**CITY OF MENASHA
PLAN COMMISSION
Council Chambers
140 Main Street, Menasha**

**May 17, 2011
3:30 PM**

2. **Site Plan Amendment – Minimax Storage – 1840 Bud Drive**

LANDSCAPE PLAN

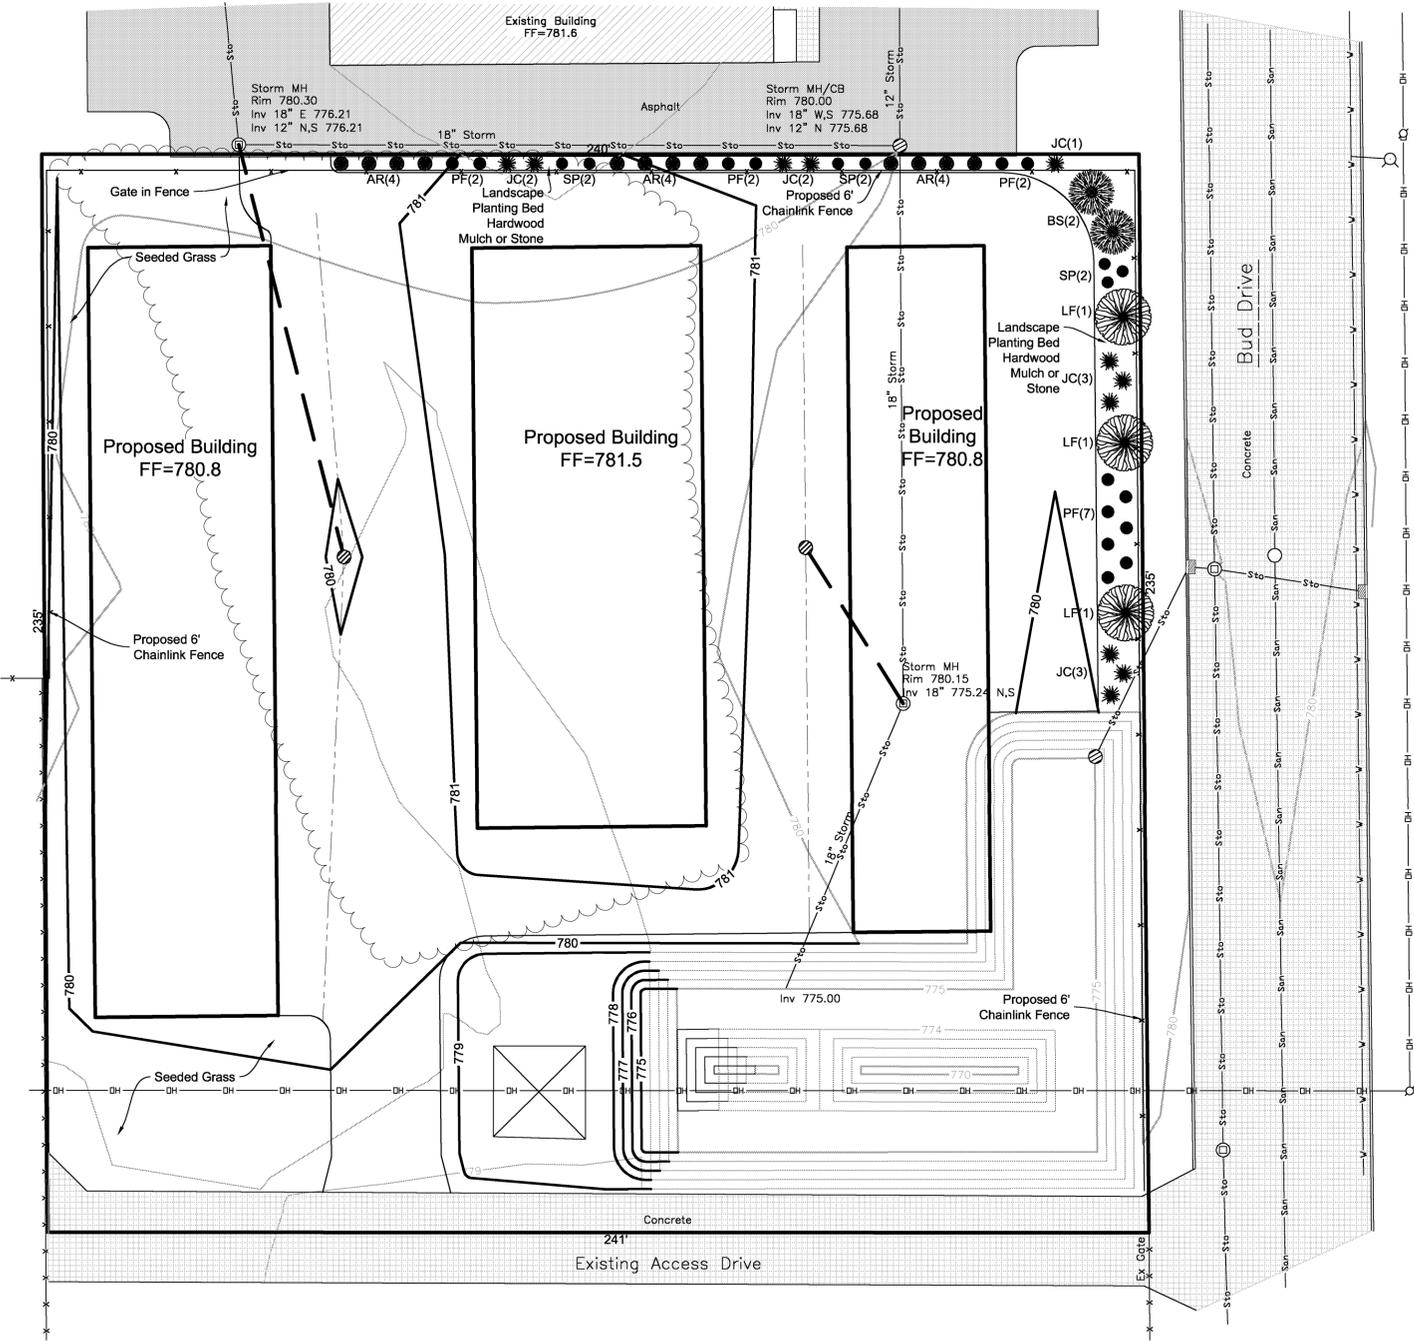
- Definition of steel panels
- Setbacks
- Landscaping
- Lighting
- Fencing

The consensus was to hold this item pending receipt of a revised site plan that met setback requirements, added landscaping along bud drive, and considers relocating the fence along Bud Drive to the west of the street ROW. Information is also to be provided about site lighting.

SHEET TITLE:
ELEVATIONS & STEEL LAYOUTS

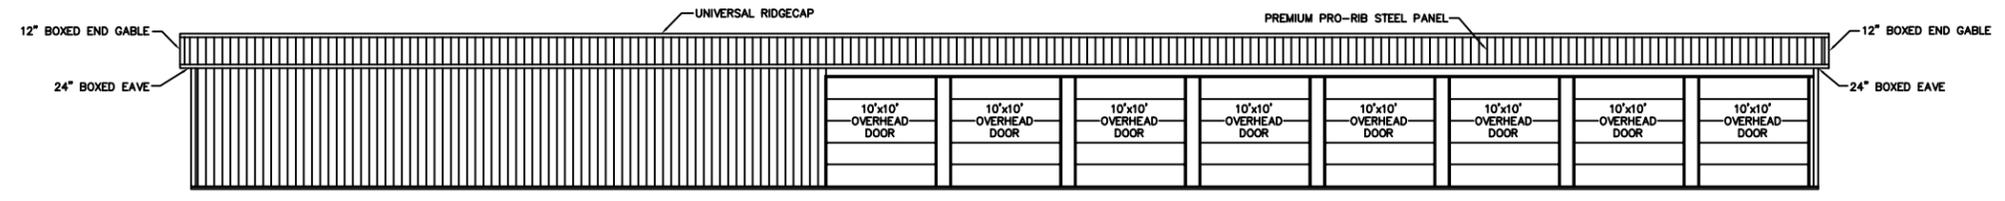
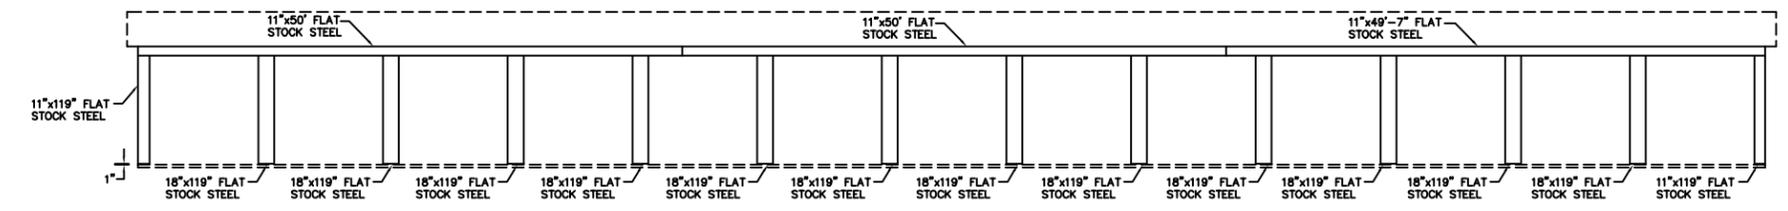
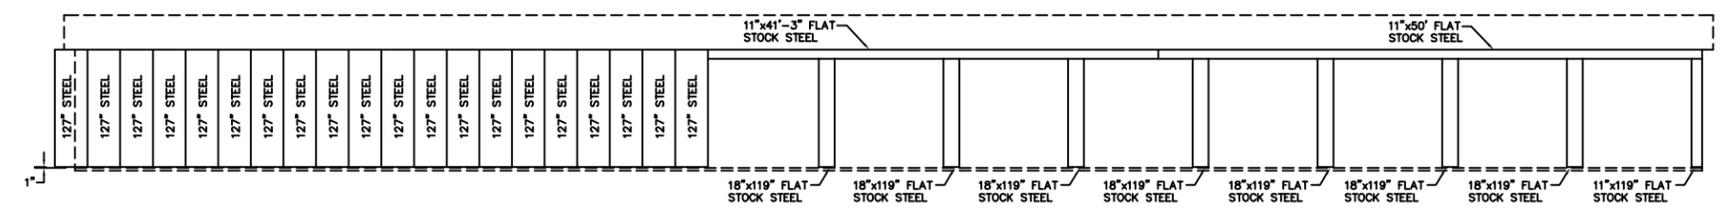
REVISIONS		
NO.	DATE	DESCRIPTION
1	5-08-11	SHORTEN BUILDING 11'-6 1/2"
2		
3		
4

PROJECT TITLE:	MINIMAX STORAGE MENASHA, WI
SHEET TITLE:	ELEVATIONS & STEEL LAYOUTS

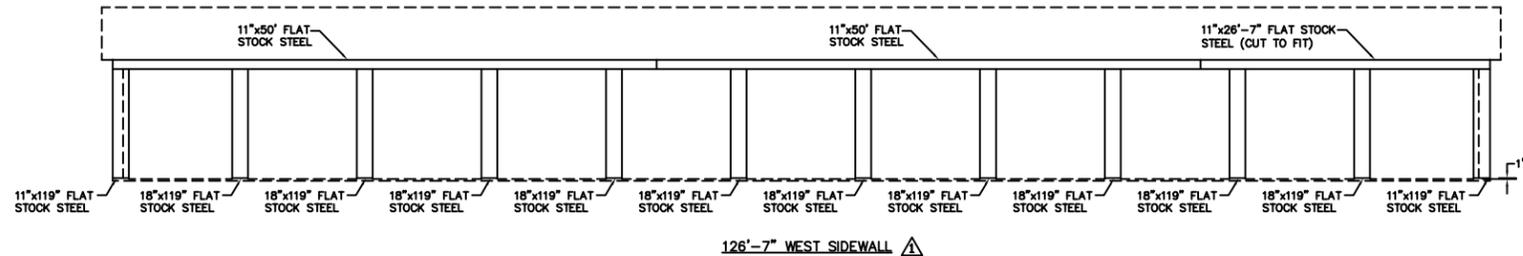
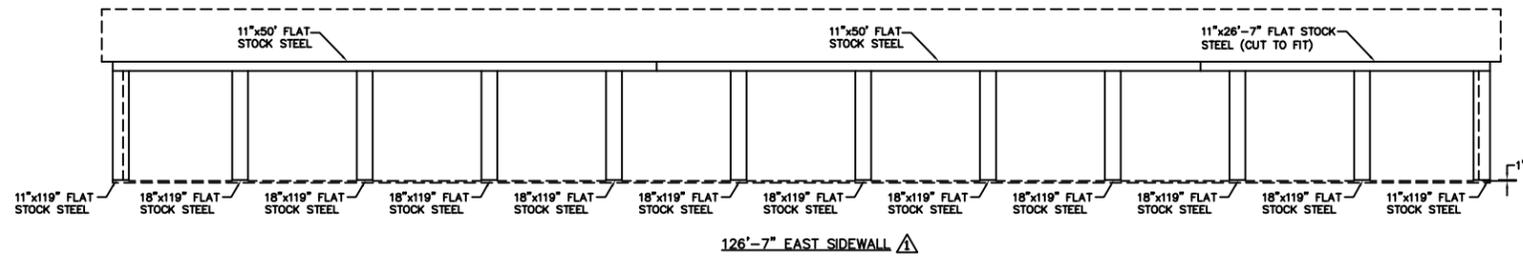
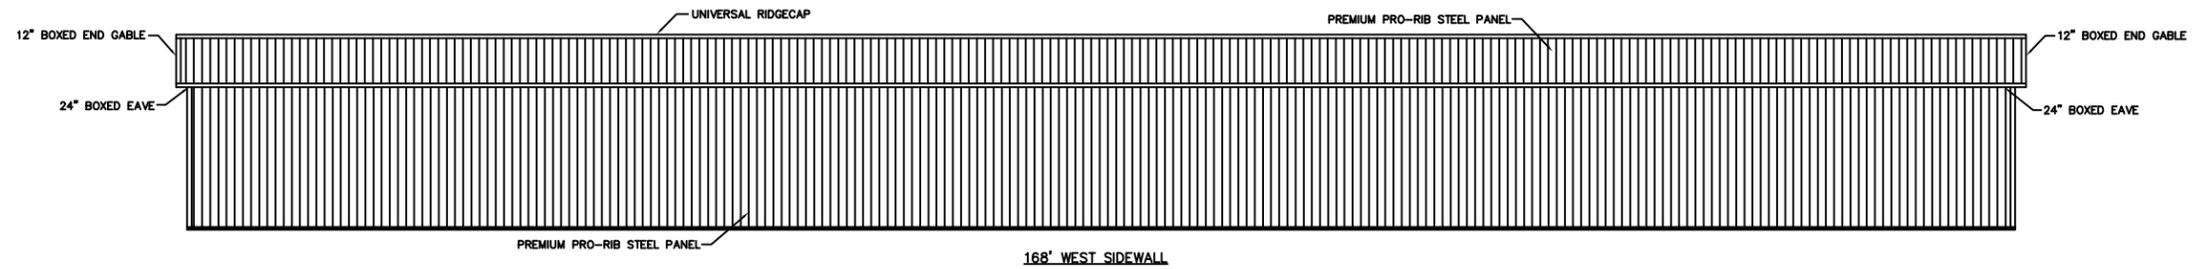
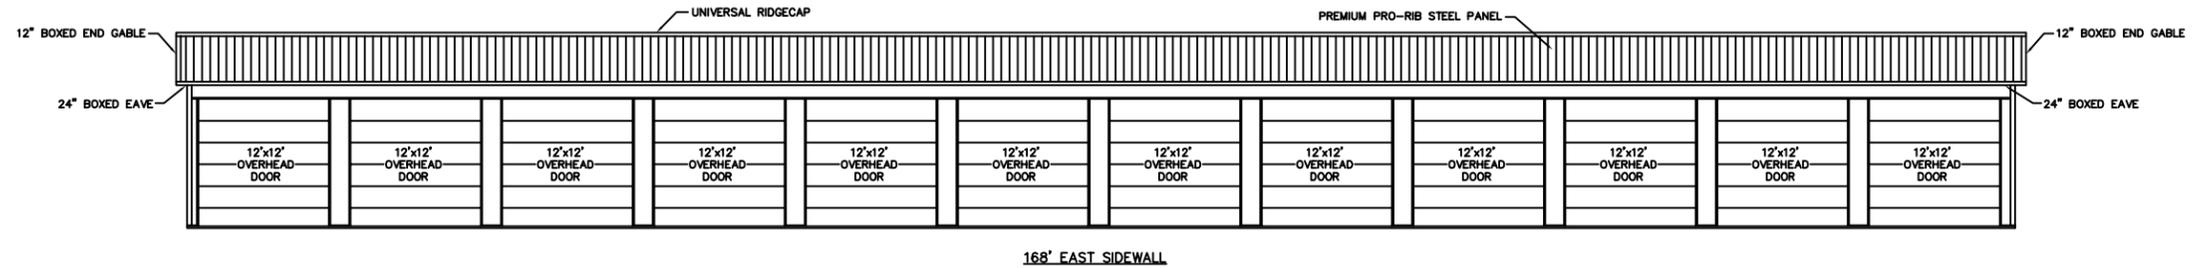
REVISIONS		
NO.	DATE	DESCRIPTION
1	5-08-11	SHORTEN BUILDING 23'-11"
2		
3		
4
